8840 CYPRESS WATERS  
2ND FLOOR CORRIDOR

NO.	REVISIONS:	DATE:
▲	PROPOSAL REQUEST #1	09/01/23
▲		
▲		
▲		
▲		
▲		
▲		
▲		
▲

DRAWING TITLE:  
LEVEL 02  
MECHANICAL PLAN

DRAWING NUMBER:  
**M2.02A**

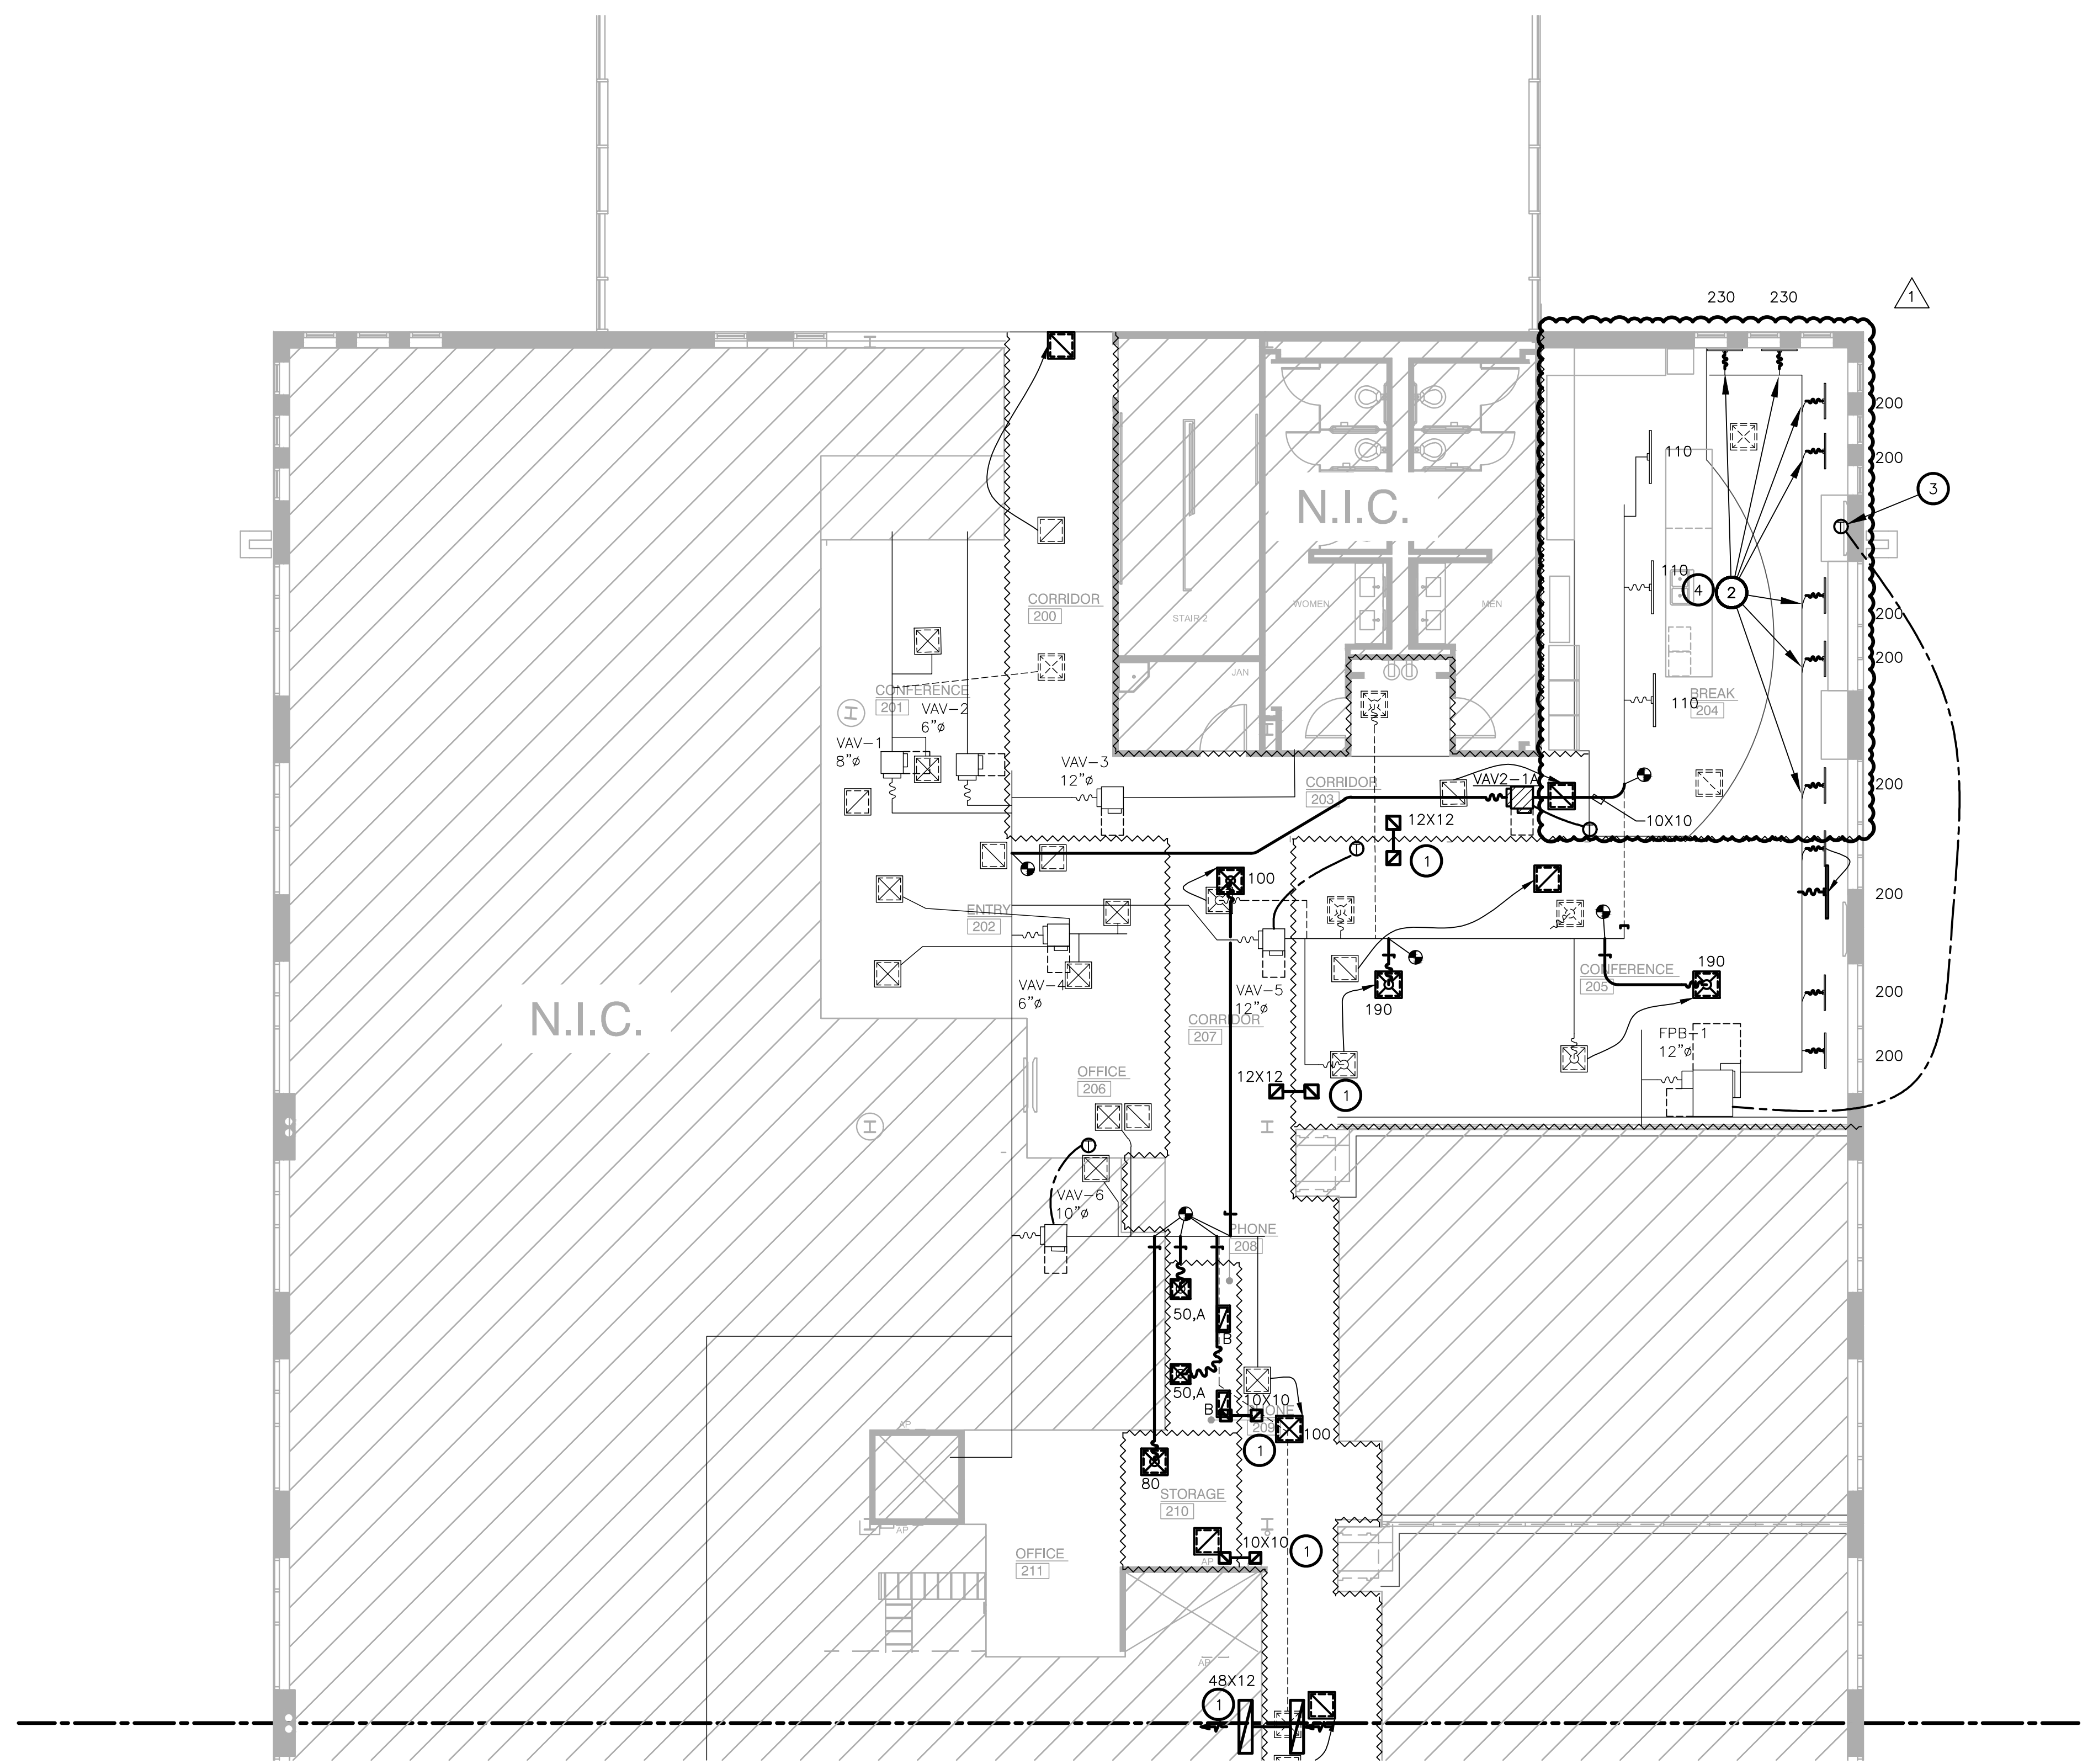
1. PROVIDE ACOUSTICALLY LINED RETURN AIR BOOT THRU WALL TO DECK AS HIGH AS POSSIBLE ABOVE CEILING WITH INLET ELBOW AND OUTLET 90° ELBOW FACING UPWARD. SIZE PER PLANS. REFER TO DETAIL SHEET M0.01 FOR MORE INFORMATION.
2. PROVIDE YOUNG REGULATOR FOR VOLUME DAMPER CONTROLS. REFER TO GENERAL NOTES FOR ADDITIONAL INFORMATION.
3. PROVIDE INSULATION PAD TO BE INSTALLED BETWEEN THERMOSTAT AND PERIMETER WALL FOR THERMOSTATS MOUNTED ON EXTERIOR COLUMN/WALLS.
4. CONTRACTOR TO RE-PURPOSE EXISTING DIFFUSERS FOR USE IN NEW GYPSUM BOARD CEILING.

REVISION SUMMARY:  
 - ADDED KEYED NOTE 4  
 - PUT EXISTING INTERIOR DIFFUSERS IN BREAK 208 BACK TO ORIGINAL LOCATION.
